# Access Compliance Report

## Public Rights-of-Way

Intersection ID: 48587	Main Street: STONEY_CREEK_LN	Cross Street: UNIVERSITY_CITY_BV	Location: SE
ADA ID: E28E98943D76	Ramp Type: BlendTrans1	Initial Pass/Fail: Fail	Overall Compliance: No
		Severity Score: 10

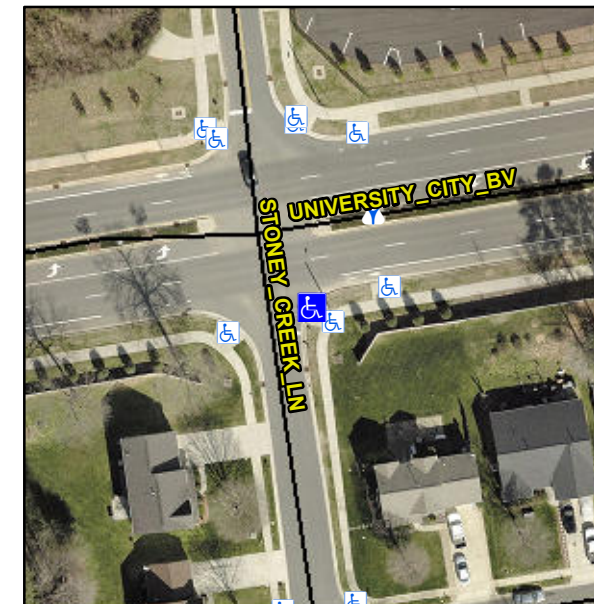
**Not Found, R304.5.1, R304.5.3**

Compliance	Description	Data	Compliance	Description	Data
N/A	Ramp Length (in)	100.0	Yes	BlendTrans Slope (%)	4.8
No	Ramp Width (in)	44.5	No	BlendTrans XSlope (%)	2.4
N/A	Flare Type LT	N/A	N/A	Flare Type RT	N/A
N/A	Flare Slope LT (%)	N/A	N/A	Flare Slope RT (%)	N/A
N/A	Flare Traversable LT?	N/A	N/A	Flare Traversable RT?	N/A
N/A	Landing Length (in)	N/A	N/A	DWS Provided?	N/A
N/A	Landing Width (in)	N/A	N/A	DWS Contrast?	N/A
N/A	Landing Slope (%)	N/A	N/A	DWS Length (in)	N/A
N/A	Landing X Slope (%)	N/A	N/A	DWS Full Width?	N/A
N/A	Landing Curb? (Y/N)	N/A	N/A	DWS Offset (in)	N/A
N/A	Shared Landing?	N/A			
N/A	Gutter Ponding?	N/A	N/A	Gutter Slope (%)	N/A
N/A	Gutter Lip Ht (in)	N/A	N/A	Gutter X Slope (%)	N/A
N/A	Painted X Walk1?	No	N/A	Painted X Walk2?	No
	X Walk 1 Direction	To N		X Walk 2 Direction	To W
	X Walk 1 Width (in)	N/A		X Walk 2 Width (in)	N/A
	X Walk 1 Slope (%)	2.2		X Walk 2 Slope (%)	0.1
	X Walk 1 X Slope (%)	0.1		X Walk 2 X Slope (%)	3.7

N/A	Ramp inside XWalk1?	N/A	N/A	Ramp inside XWalk2?	N/A
	Road Slope (%)	3.3		Clear Space?	N/A
	Road X Slope (%)	1.4	N/A	Clear Space to XWalk (in)	N/A
N/A	Any Obstructions?	N/A	N/A	Storm Grate/Utility Hazard?	N/A
	Obstruction Type			Storm Grate/Utility Type	
		N/A			N/A
			Yes	Surface Condition? (G/P)	Good
			No	Curb Slope (%)	10.4

**Remove & Replace Curb Ramp With Two New Directional Ramps or Equivalent.**
